Permit No. 92196 Cost \$219,000.00
 Address 1427-31 Alton Road
 Bond No.
 Engineer Str. Ruben Baren P.E.
 Lot Size 100 X 150
 Height 31 Ft. Stories 2
 Use

DESCRIPTION OF WORK TO BE DONE: New Const New 2 sty CBS Commercial Bldg

SHEET NO S-1		ARCHITECT: JAIME SALLES	NEW TWO STORY COMMERCIAL BUILDING AT 1431 TO 1427 ALTON ROAD MIAMI BEACH FLORIDA
DATE: MAY 26/87		CONSULTANT: RODOLFO BUIGAS	
		DRAWN BY: R.B.

FOUNDATION & GROUND FLOOR FRAMING PLAN
 18' x 110'
 DESIGN FLOOR DESIGNED FOR LL=125 PSF
 R_c = 3000 PSI

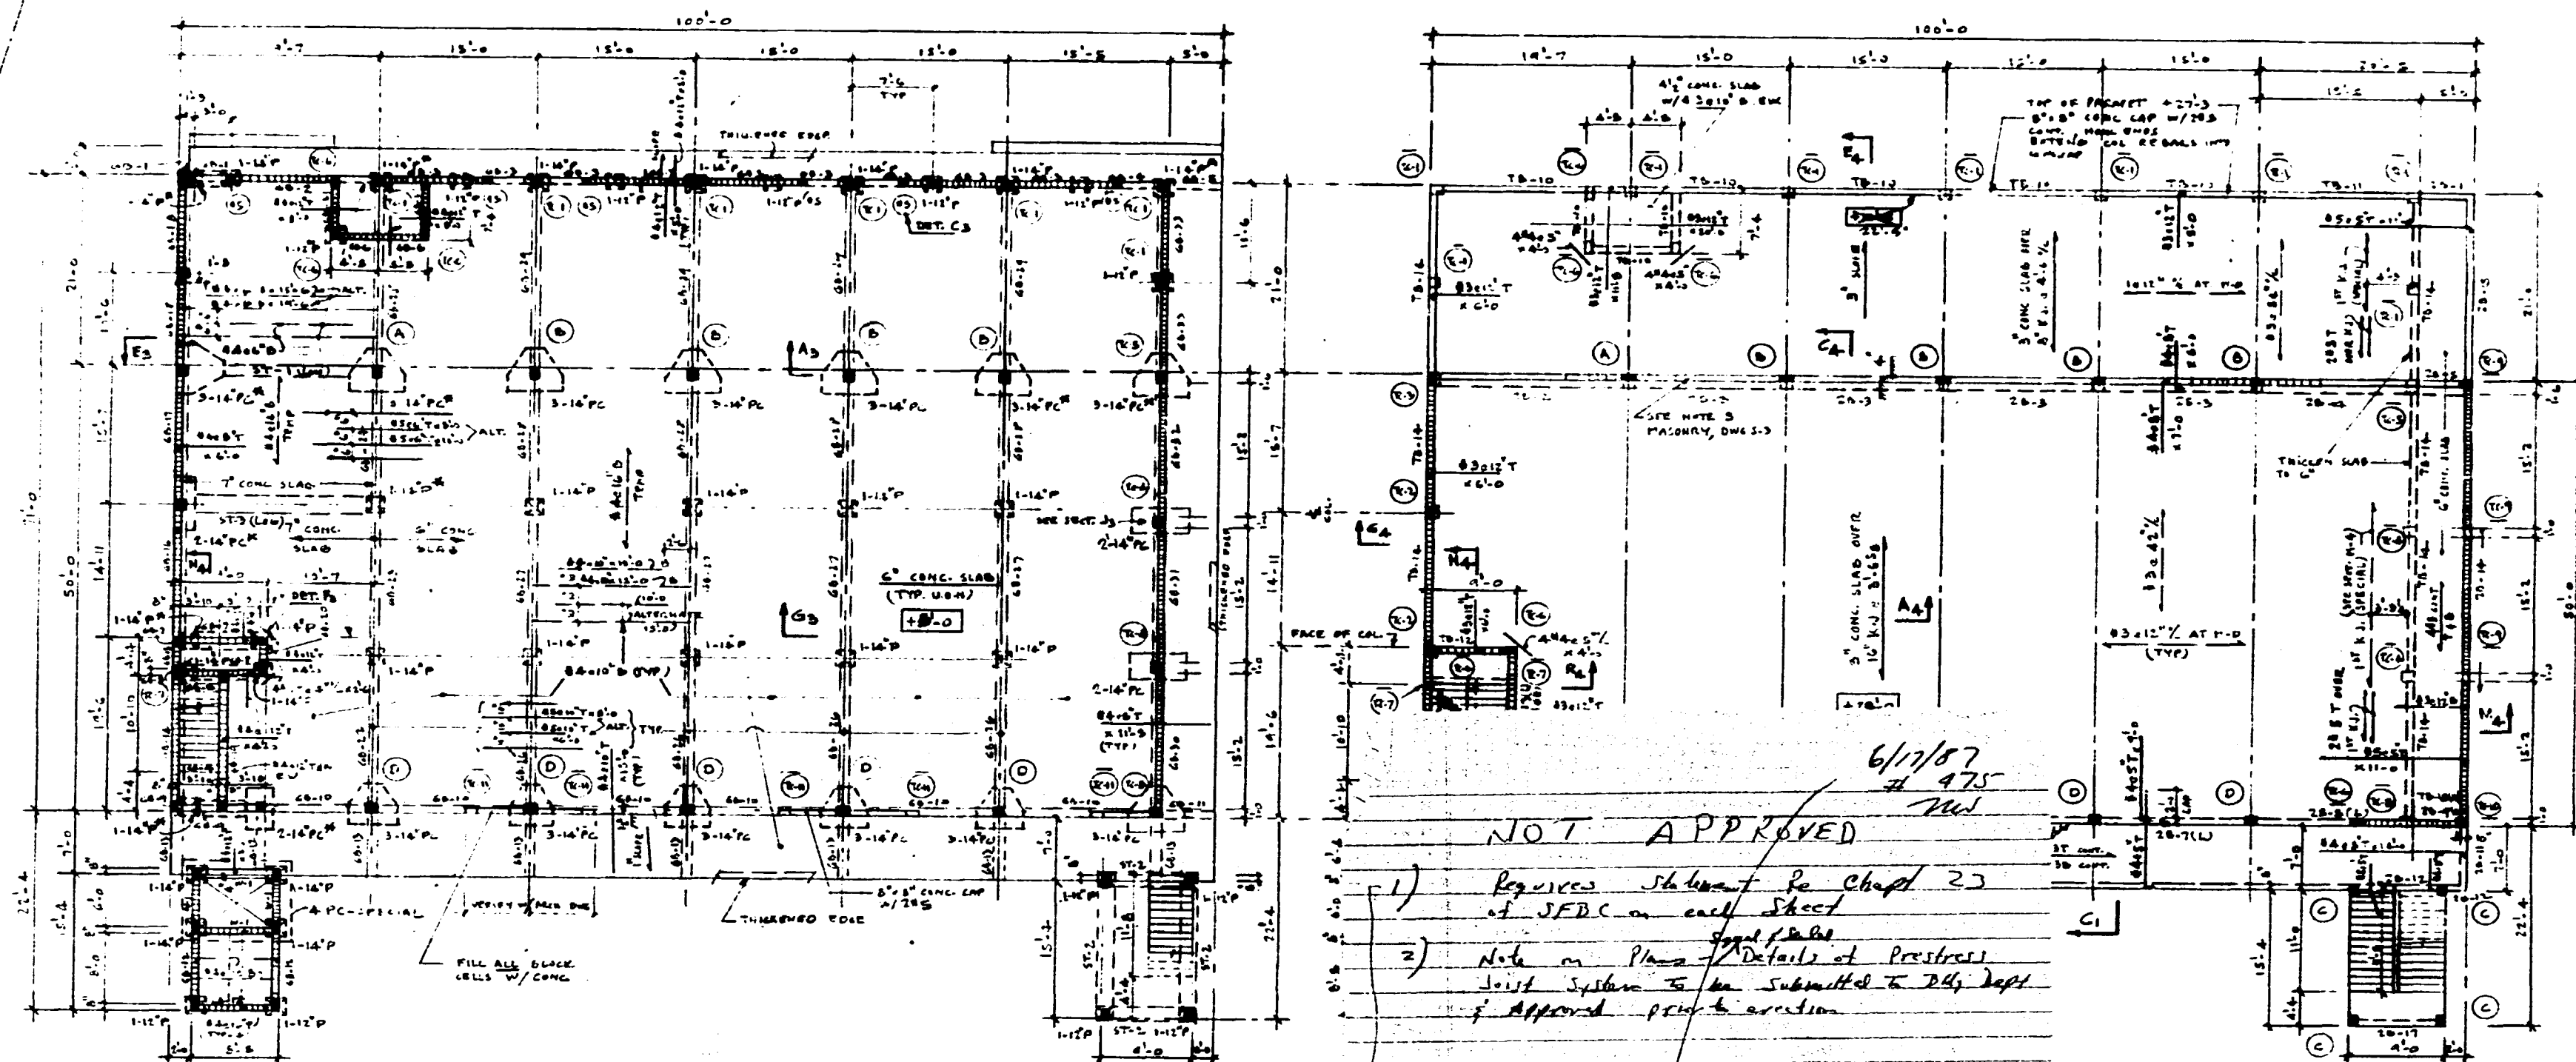
6/7/87
 # 975
 NOT APPROVED

1) Review sheet re Chap 23
 of S.F.D.C. on each sheet

2) Note on Plans / Details of Prestress
 Joint System to be submitted to D.C. Dept.
 of approved prior to erection

Structures shown on this sheet have been
 designed in accordance with S.F.D.C. Chap 23
 As Revised to comply with Dade County
 Coastal Construction Code of 1987
 Signed: *[Signature]*

7/11/87 Corrections made
